Display

Model: **BVM-D9H1U, BVM-D9H5U**

Subject: **SLOW STARTUP WHEN DC-POWERED**

Figure 1

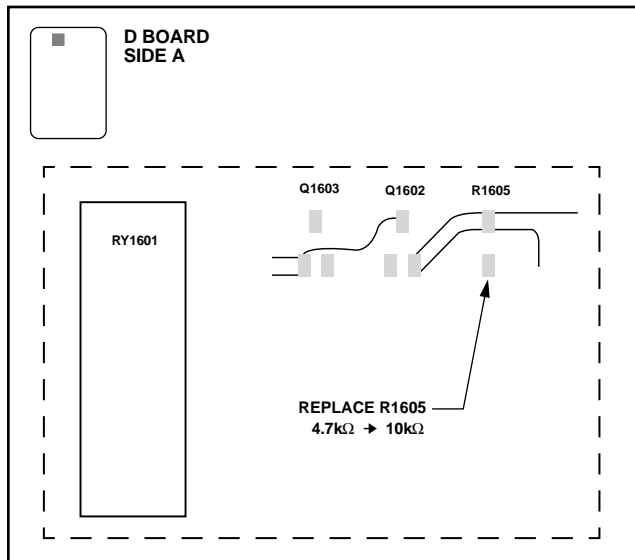
When the unit is DC-powered by a lithium battery (BP-L90, 90A, 60 and 60A), it takes more than 30 seconds to start up; when powered by an AC-pack, startup is normal. To correct this condition, replace former (4.7kΩ) resistor R1605 on the D board (side A, zone A-1) with the new 10kΩ part. (See Figure 1.)

| Part No. | Description | Qty. |
|--------------|-------------------------|------|
| 1-208-806-11 | Res, Chip, 10kΩ (R1605) | 1 |
